Groundwater Transfer Review Summary Form

Transfer/PA # T- 14542

Application: T-14542

Applicant Name: Patrick and Denise Beggs

Map**T-14542 Beggs**

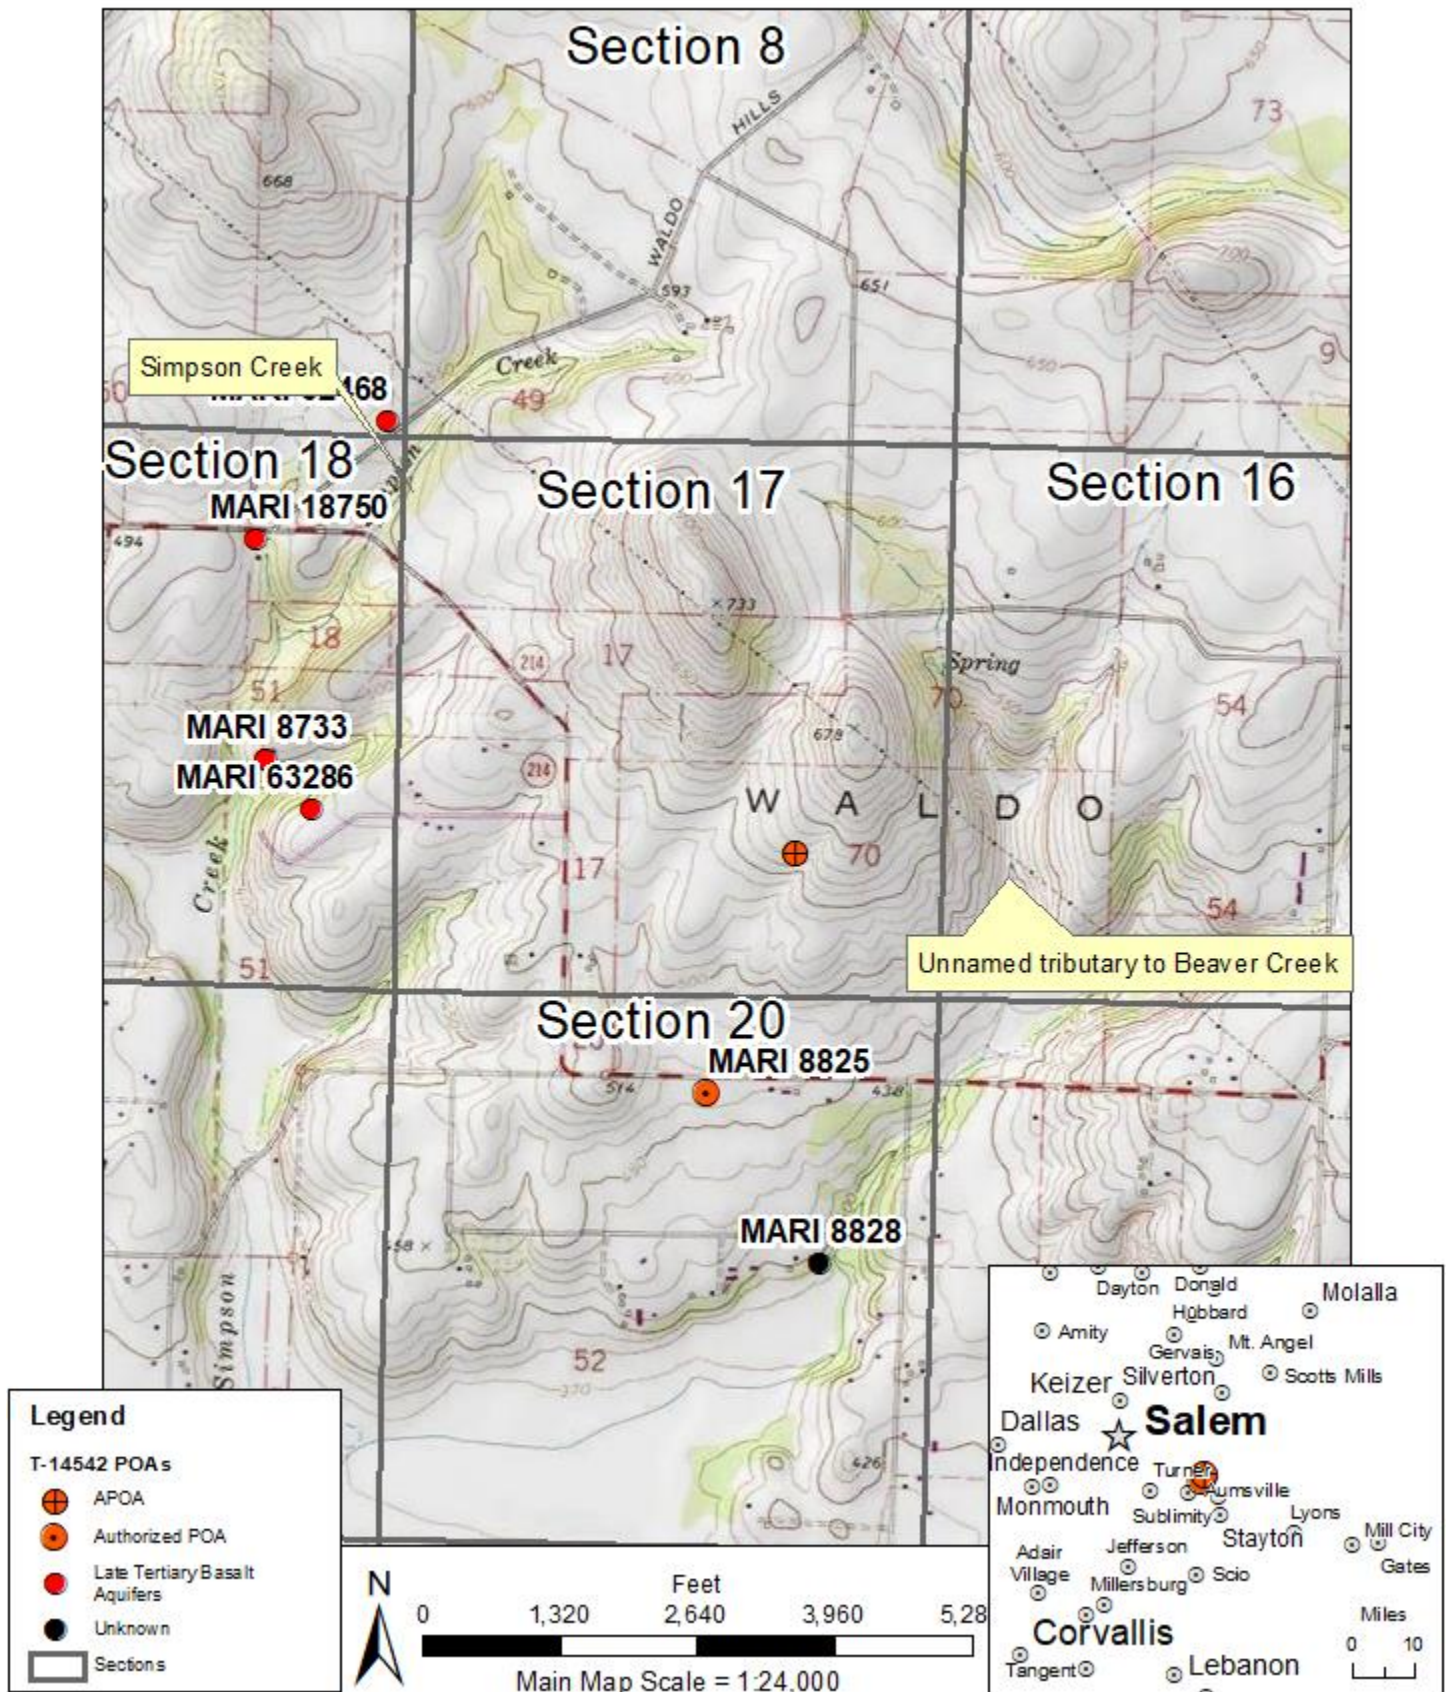
2. Will the proposed POA develop the same aquifer (source) as the existing authorized POA?
☒ Yes ☐ No Comments: The authorized POA (**MARI 8825/8812**) develops the weathered top of the Sand Hollow Basalt belonging to the Frenchman Springs member of the Wanapum Basalt Formation (Tolan and Beeson, 1999), part of the Columbia River Basalt Group, CRBG. The well is completed to 600 ft bls [-136 ft amsl], with water-bearing zones (WBZs) from 23 ft bls [441 ft amsl] to 350 ft bls [114 ft amsl]; when the well was deepened to 600 ft bls [-136 ft amsl], the driller noted "No water encountered". The proposed APOA (**PROP 556**) would likely develop the same Sand Hollow Basalt, with proposed casing and surface seal to 30 ft bls [543 ft amsl] and a maximum depth of 250 ft bls [323 ft amsl]. It is anticipated that the proposed APOA (**PROP 556**) will develop the same aquifer as the authorized POA (**MARI 8825/8812**).

5. a) Will this proposed change, at its maximum allowed rate of use, likely result in an increase in interference with **another ground water right**?
☐ Yes ☒ No Comments: The authorized POA (MARI 8825/8812) is closer to the nearest ground water user than the proposed APOA (PROP 556). A decrease in interference with other ground water users is anticipated.

6. a) Will this proposed change, at its maximum allowed rate of use, likely result in an increase in interference with **another surface water source**?
☐ Yes ☒ No Comments: The authorized POA (MARI 8825/8812) is closer to the nearest surface water source than the proposed APOA (PROP 556). A decrease in interference with surface water is anticipated.
